Source: TSG CN WG 1
Title: CRs to R99 (with mirror CRs) on Work Item TEI towards 24.008
Agenda item: 7.11
Document for: APPROVAL

This document contains **8** CRs, **R99** Work Item "TEI", that have been agreed by **TSG CN WG1** in **CN1#34 meeting**, and are forwarded to TSG CN Plenary meeting #24 for approval.

⌘ **24.008 CR 857** ⌘ rev **1** ⌘ Current version: **3.18.0** ⌘

Title:	⌘ Correction of the network initiated in-call modification
Source:	⌘ Siemens
Work item code:	⌘ TEI Date: ⌘ 30.04.2004
Category:	⌘ F Release: ⌘ R99
Use <u>one</u> of the following categories:	
F (correction)	
A (corresponds to a correction in an earlier release)	
B (addition of feature),	
C (functional modification of feature)	
D (editorial modification)	
Detailed explanations of the above categories can be found in 3GPP TR 21.900 .	
Use <u>one</u> of the following releases:	
2 (GSM Phase 2)	
R96 (Release 1996)	
R97 (Release 1997)	
R98 (Release 1998)	
R99 (Release 1999)	
Rel-4 (Release 4)	
Rel-5 (Release 5)	
Rel-6 (Release 6)

Figure 5.10b/3GPP TS 24.008 In-call modification sequence initiated by network

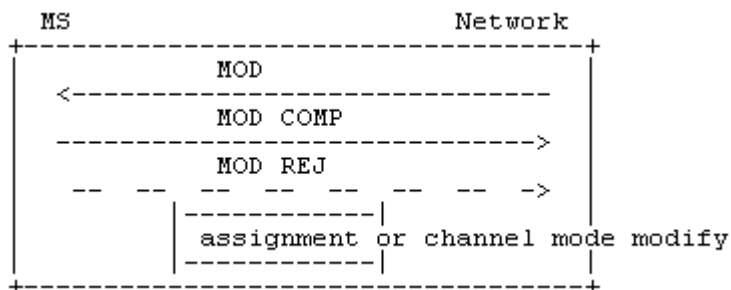
Reason for change: ⌘ 1) The procedural description of the network initiated in-call modification in subclause 5.3.4.3.2 suggests that the MS waits for the change of the channel configuration before it returns a MODIFY COMPLETE message to the network.

This is not in line with figure 5.10b at the end of subclause 5.3.4.4, which suggests the opposite order of sequence, i.e. the MS returns MODIFY COMPLETE before the channel configuration is changed.

4) The proposed change (alignment with fig. 5.10b) is also in line with the example message flows for the service change that were added to the SCUDIF stage 2, TS 23.153, in v.5.2.0.

5) If the order of sequence is aligned with figure 5.10b, then the Immediate modification indicator IE is no longer needed. This indicator was introduced for a special case of the network initiated in-call modification where no change of the traffic channel is necessary. If the MS always returns the MODIFY COMPLETE message before the channel reconfiguration takes place, if any needed, then no special indication is necessary.

Summary of change: ⌘ The description of the network initiated in-call modification is aligned with fig. 5.10b, i.e. the MS is mandated to send the MODIFY COMPLETE message before the channel is reconfigured.

The Immediate modification indicator IE is removed from TS 24.008.

Figure 5.10b/3GPP TS 24.008 In-call modification sequence initiated by network

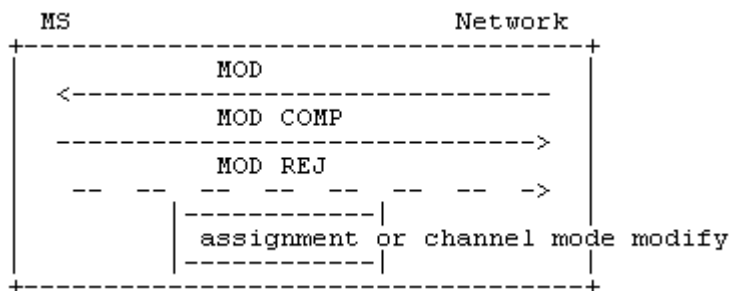
- 1) The procedural description of the network initiated in-call modification in subclause 5.3.4.3.2 suggests that the MS waits for the change of the channel configuration before it returns a MODIFY COMPLETE message to the network.

This is not in line with figure 5.10b at the end of subclause 5.3.4.4, which suggests the opposite order of sequence, i.e. the MS returns MODIFY COMPLETE before the channel configuration is changed.

4) The proposed change (alignment with fig. 5.10b) is also in line with the example message flows for the service change that were added to the SCUDIF stage 2, TS 23.153, in v.5.2.0.

5) If the order of sequence is aligned with figure 5.10b, then the Immediate modification indicator IE is no longer needed. This indicator was introduced for a special case of the network initiated in-call modification where no change of the traffic channel is necessary. If the MS always returns the MODIFY COMPLETE message before the channel reconfiguration takes place, if any needed, then no special indication is necessary.

Summary of change: ⌘ The description of the network initiated in-call modification is aligned with fig. 5.10b, i.e. the MS is mandated to send the MODIFY COMPLETE message before the channel is reconfigured.

The Immediate modification indicator IE is removed from TS 24.008.

Figure 5.10b/3GPP TS 24.008 In-call modification sequence initiated by network

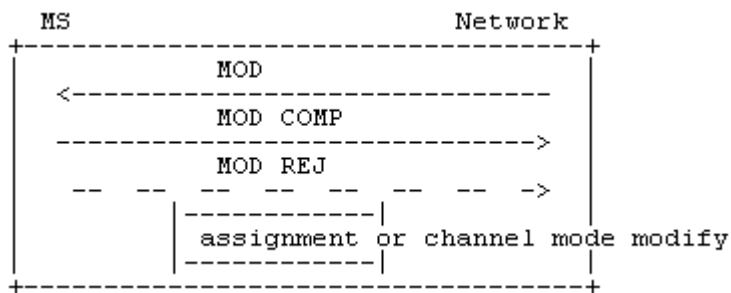
- 1) The procedural description of the network initiated in-call modification in subclause 5.3.4.3.2 suggests that the MS waits for the change of the channel configuration before it returns a MODIFY COMPLETE message to the network.

This is not in line with figure 5.10b at the end of subclause 5.3.4.4, which suggests the opposite order of sequence, i.e. the MS returns MODIFY COMPLETE before the channel configuration is changed.

4) The proposed change (alignment with fig. 5.10b) is also in line with the example message flows for the service change that were added to the SCUDIF stage 2, TS 23.153, in v.5.2.0.

5) If the order of sequence is aligned with figure 5.10b, then the Immediate modification indicator IE is no longer needed. This indicator was introduced for a special case of the network initiated in-call modification where no change of the traffic channel is necessary. If the MS always returns the MODIFY COMPLETE message before the channel reconfiguration takes place, if any needed, then no special indication is necessary.

Summary of change: ⌘ The description of the network initiated in-call modification is aligned with fig. 5.10b, i.e. the MS is mandated to send the MODIFY COMPLETE message before the channel is reconfigured.

The Immediate modification indicator IE is removed from TS 24.008.

Figure 5.10b/3GPP TS 24.008 In-call modification sequence initiated by network

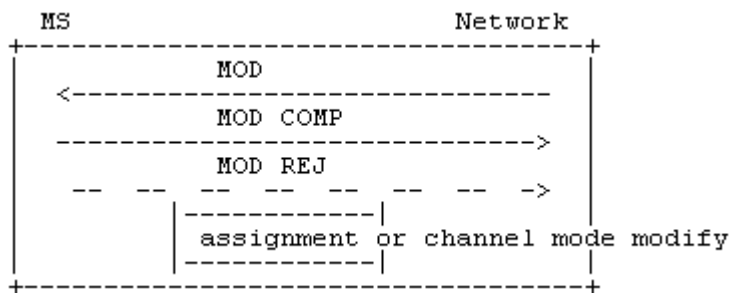
Reason for change: ⌘ 1) The procedural description of the network initiated in-call modification in subclause 5.3.4.3.2 suggests that the MS waits for the change of the channel configuration before it returns a MODIFY COMPLETE message to the network.

This is not in line with figure 5.10b at the end of subclause 5.3.4.4, which suggests the opposite order of sequence, i.e. the MS returns MODIFY COMPLETE before the channel configuration is changed.

4) The proposed change (alignment with fig. 5.10b) is also in line with the example message flows for the service change that were added to the SCUDIF stage 2, TS 23.153, in v.5.2.0.

5) If the order of sequence is aligned with figure 5.10b, then the Immediate modification indicator IE is no longer needed. This indicator was introduced for a special case of the network initiated in-call modification where no change of the traffic channel is necessary. If the MS always returns the MODIFY COMPLETE message before the channel reconfiguration takes place, if any needed, then no special indication is necessary.

Summary of change: ⌘ The description of the network initiated in-call modification is aligned with fig. 5.10b, i.e. the MS is mandated to send the MODIFY COMPLETE message before the channel is reconfigure.

The Immediate modification indicator IE is removed from TS 24.008.
